Office of Engineering  
Project Development Division  
Bridge Design Section  
PO Box 94245 | Baton Rouge, LA 70804-9245

## MEMORANDUM

SUBJECT: BRIDGE DESIGN TECHNICAL MEMORANDUM NO.109 (BDTM.109) -  
SOUND BARRIER DESIGN

DATE: December 22, 2021

**Figure 15.4.1.2-1**

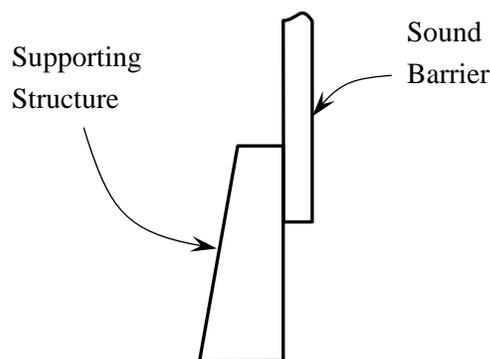
Attach structure-mounted sound barriers directly to bridge railing, concrete barriers, walls, or other supporting structure in accordance with Figure 15.4.1.2-1 using a setback distance that results in the sound barrier being immediately behind the supporting structure with no gap.
